Longview Estates Development

Lahardane, Ballyvolane, Cork

Stage 1/2 Road Safety Audit

Client	Longview Estates Ltd.
Project Title	Longview Estates Development
Document Title	Road Safety Audit – Stage 1
Document No.	19094RS-Doc01
Job No.	19094RS

Figure 2.1

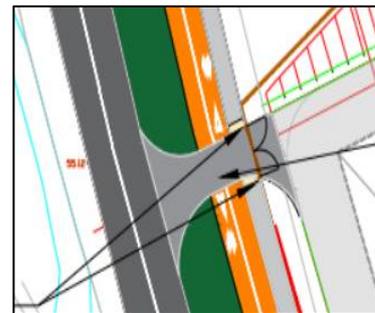
Priority has been given to vehicles at the point where the cycle/pedestrian facility passes the entrance to the proposed pump station. Failure to provide an appropriate crossing point with priority for vulnerable road users on a ped/cycle facility may lead to pedestrians/cyclists/ or visually/mobility impaired users misinterpreting priority at junctions resulting in collisions with entering and exiting vehicles. Refer to Figure 2.1.

Provide a raised entry treatment with appropriate tactile paving at the crossing point in accordance with the relevant guidelines.

Figure 2.2

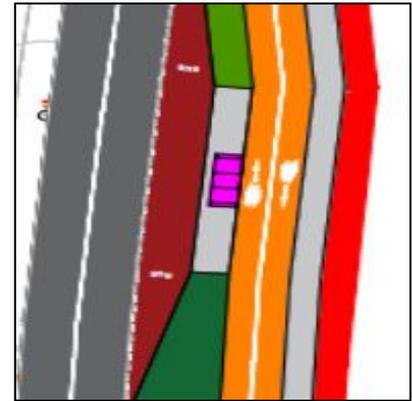
No warning has been provided to motorists of the pedestrian/cyclist crossing facility and no warning has been provided to cyclists of the termination of the cycle facility. The lack of a Stop or yield road markings for the cycle facility may lead to incorrect assumptions of priority. The potential for vehicle/cyclist or vehicle/pedestrian collisions is high, particularly given the historical collision statistics. See Figure 2.2.

Provide the appropriate signage and road marking at and in advance warning of the cycle lane ending and crossing point in accordance with the relevant standards and guidelines.

Figure 2.4

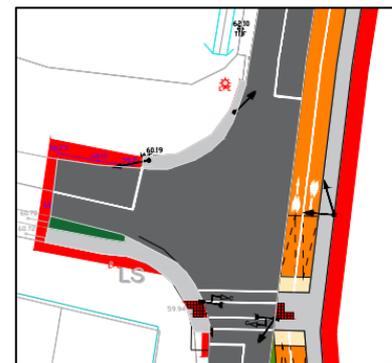
The tactile paving arrangement shown at the proposed signalled junction as shown in Figure 2.4 is incorrect. The leg extending away from the road edge should be on the approaching traffic side and it should extend to the back of the footpath. Failure to provide tactile paving to the recommended layouts could lead to confusion for the visually impaired Resulting in potential collisions with passing vehicles.

The width of the proposed crossing is not defined on the drawings. As it is envisaged that both cyclists and pedestrians will want to cross the R614 at this location and the signal aspect diagram indicates same, however there doesn't appear to be adequate width to accommodate both pedestrians and cyclists. Failure to provide appropriate crossing width could lead to collisions between pedestrians and cyclists. Refer to Figure 2.4 above

The two-way raised off road cycle track from J2 to J3 introduces a contraflow cycle facility arrangement for uphill cyclists, with no protection other than the raised kerb. There is potential for an uphill cyclist (northbound) to wobble out onto the downhill trafficked carriageway with potential for serious vehicle/cycle collisions. As the height of the raised facility is unclear, the higher the kerb the more serious the consequences of a fall from the kerb. See Figure 2.4.

There appears to be no primary signal head on the left hand side at carriageway level for traffic approaching from the north towards the proposed signalised junction as per Figure 2.4 above. Failure to provide the appropriate signal heads could lead to vehicles being unable to see the traffic signals in advance of the stop line and misinterpreting priority at the junction and leading to collisions with traffic approaching from the Kilbarry Link road. There is also potential for rear end shunt collisions as drivers become aware of the signal control when it is too late to decelerate over a safe distance.

Provide the appropriate tactile paving design to inform all road users about the controlled crossing location and form in accordance with the relevant guidelines.

Provide the appropriate crossing width that will incorporate both pedestrians and cyclists in accordance with the relevant guidelines. A combined pedestrian/cyclist facility should normally have a minimum width of 4.0m.

Provide protection to the cyclists by provision of a barrier between the cycle track and the road or green space similar to between J1 and J2 further south.

Review the existing Traffic Signals layout in accordance with the relevant guidelines. Consider use of high level cantilever poles for the northern approach.

Figure 2.5

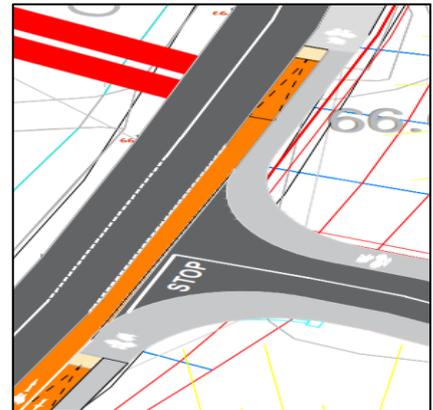
No provision has been made for uphill cyclists to enter the development from the Ballyhooly Road and getting access to the shared facility inside the estate or to continue on there journey safely uphill on the R614. Failure to design an appropriate end to the cycle track could result in collisions between cyclists crossing the R614 and motorists or with vehicles using the development access.

No provision has been made for pedestrians to cross at the entrance to the development. Failure to provide an appropriate crossing point may lead to pedestrians and or visually impaired users misinterpreting priority at junctions resulting in collisions with entering and exiting vehicles. Refer to Figure 2.5.

Provide the appropriate design with signage and road markings in advance of the cycle facility ending in accordance with the relevant standards.

Provide an appropriate crossing point for pedestrians and all vulnerable road users in accordance with the relevant guidelines. A raised entry treatment should be considered.

Figure 2.6

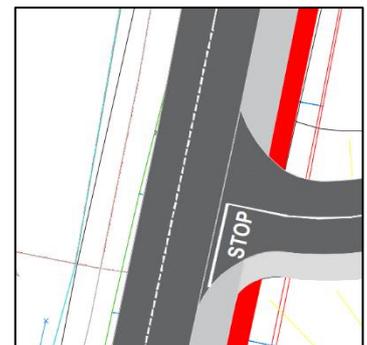
No provision has been made for pedestrians or cyclists to cross at the entrance to the development. Failure to provide an appropriate crossing point may lead to pedestrians or visually impaired users misinterpreting priority at junctions resulting in collisions with entering and exiting vehicles. Refer to Figure 2.6. Refer to Figure 6.

Provide the appropriate crossing point for pedestrians, cyclists, mobility impaired and visually impaired users in accordance with the relevant guidelines.

Figure 2.7

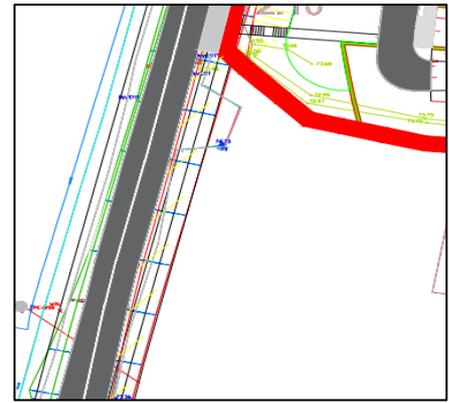
The footpath/shared surface along the R614 is terminated at approximately 70m south of Junction 4 for a distance of 100m. Failure to provide footpath connectivity along a road will force vulnerable road users to enter the trafficked carriageway leading to potential collisions with passing vehicles. Refer to Figure 2.7.

No provision has been made for pedestrians or cyclists to cross at the entrance to the development. Failure to provide an appropriate crossing point may lead to pedestrians or visually impaired users misinterpreting priority at junctions resulting in collisions with entering and exiting vehicles. Refer to Figure 2.7.

Ensure that footpath connectivity is provided throughout the extent of the scheme works.

Provide the appropriate crossing point for pedestrians and or visually impaired users in accordance with the relevant guidelines.
